APPLICATION NO.	FILING DATE	FIRST NAMED INVENTOR	ATTORNEY DOCKET NO.	CONFIRMATION NO.
10/590,139	02/11/2008	Neil Duggal	HO-P03203US0	5647
44270	7590	03/16/2010		
IMDS, INC. 124 SOUTH 600 WEST LOGAN, UT 84321			EXAMINER SNOW, BRUCE EDWARD	
			ART UNIT 3738	PAPER NUMBER
			NOTIFICATION DATE 03/16/2010	DELIVERY MODE ELECTRONIC

Office Action Summary	Application No. 10/590,139	Applicant(s) DUGGAL ET AL.	
	Examiner Bruce E. Snow	Art Unit 3738

DETAILED ACTION

fig. 8c

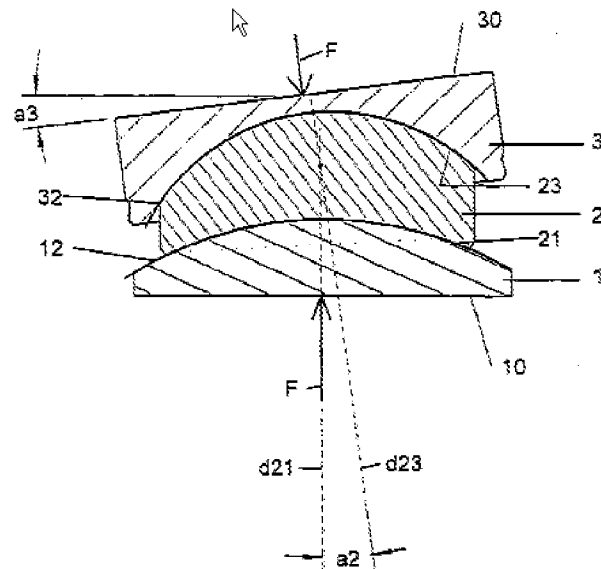
The prosthesis further comprising a nucleus 2 which articulates between said first and second plates which urges the plates into a relative anterior/posterior angle that provides a lordotic angle as shown in figure 8c.

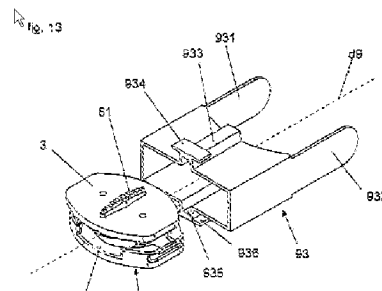
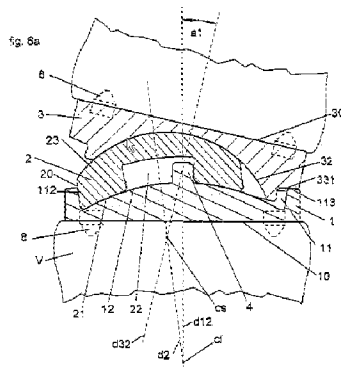
a first end plate 1 and a second end plate 3 which can comprise bone engagement features such as 8 or 81 as shown in figures 6a and 13.

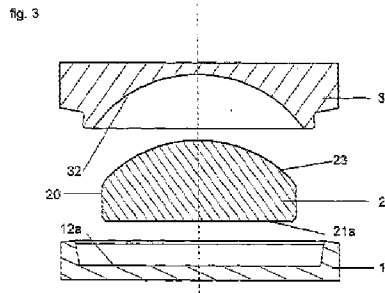
Regarding at least claim 42, having a flattened section, Beaurain et al teaches many embodiments having a flattened section such as figure 3, articulating surfaces

21a and 12a (first and second orientation features). Canted relative upper and lower plates are not required for this claim.

Claim 43, the flatten section is contiguous with the upper curved articulating surface.

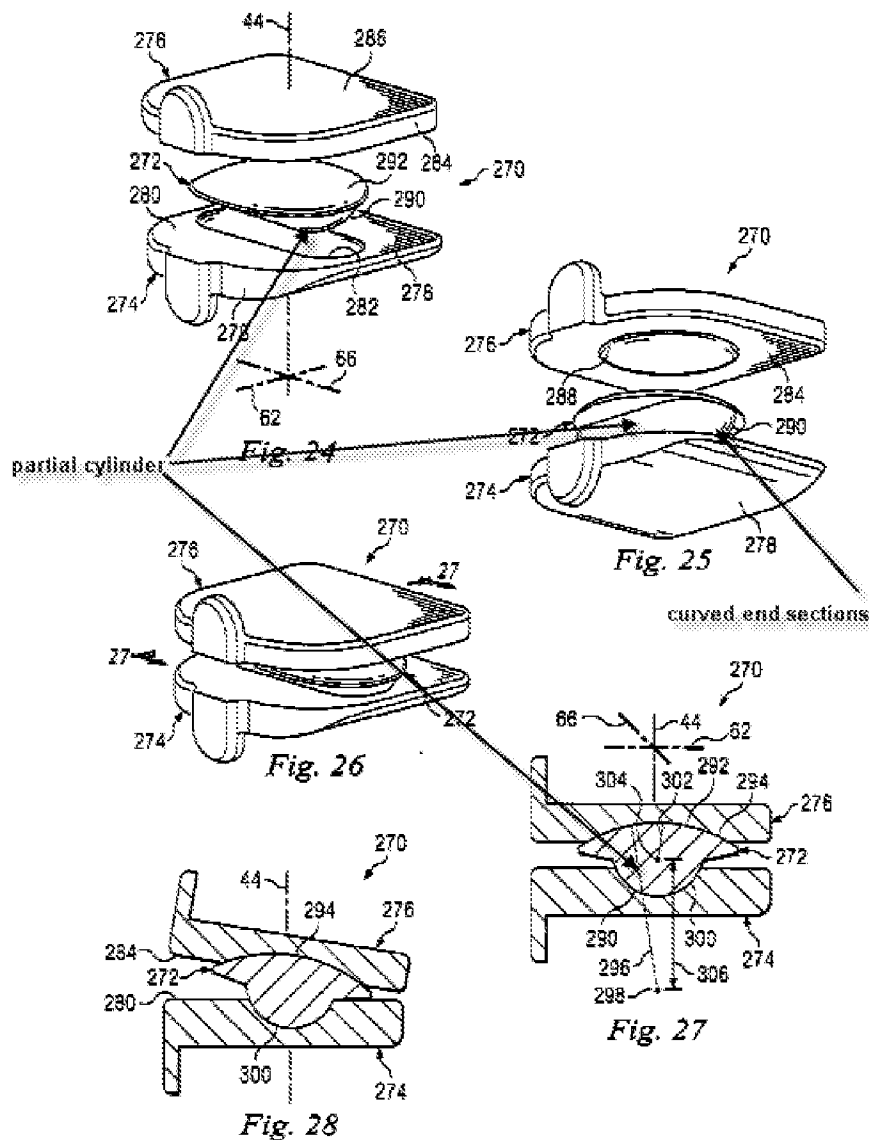
Marik et al teaches an intervertebral disc prosthesis comprising

a first end plate 274 and a second end plate 276 which can comprise bone engagement features such as a flange (stop). The prosthesis further comprising a nucleus 272 which articulates between said first and second plates which urges the plates into a relative anterior/posterior orientation that provides a preferred lordotic angle including 0.

Regarding claims 33, 39, 54, 60 a cross section at the posterior can be taken closer to the posterior end when compared to a cross section at the anterior end taken further from anterior end; the chosen anterior portion would have a greater thickness than the chosen posterior portion. The device is interpreted as having a preferred lordotic angle greater than zero.

Regarding at least claims 43, Marik et al teaches a partial cylinder (as shown) which comprises a flattened portion in one cross section flanked by first and second curved ends which inherently have a different radii.

Claim 52, see surface 284 which comprises a concave recess and a flat portion. Also see paragraph 0066 which states, "the interior surface may include a concave recess 288" which is interpreted as being optional.

Claims 57 and 62, under 35 U.S.C. 103(a), it would have been obvious to one having ordinary skill in the art to put a hole in the flange for a screw with predictable results. This is well known in the art.

Claim 58, fourth surface 288 is interpreted as being substantially flat.
